## HISTORIC PRESERVATION BOARD STAFF REPORT

### 44 E Atlantic Avenue

Meeting	File No.	Application Type
October 2, 2019	2019-192	Certificate of Appropriateness

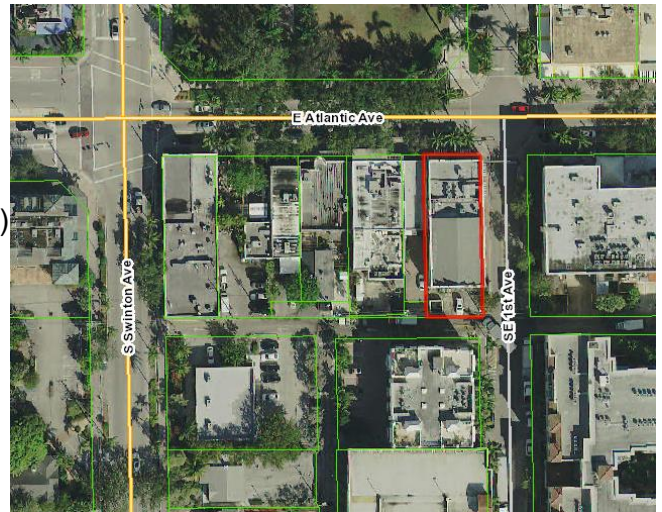
The item before the Board is for consideration of a Certificate of Appropriateness (2019-192) request for a mural and exterior modification of a contributing property, located at **44 E Atlantic Avenue, Old School Square Historic District**, pursuant to LDR Section 2.4.6(H)(5) and 2.4.5(I)(5). Specifically, the request includes: an exterior color change, replacement of 4 existing ground floor windows and doors, replacement of fabric on all awnings, replacement of lighting fixtures, refinishing of awning frames and outdoor staircase, replacement of a fabric entry awning with an aluminum, architectural canopy, and the painting of a mural on the top of the exterior of the building on the east, south, and west elevations.
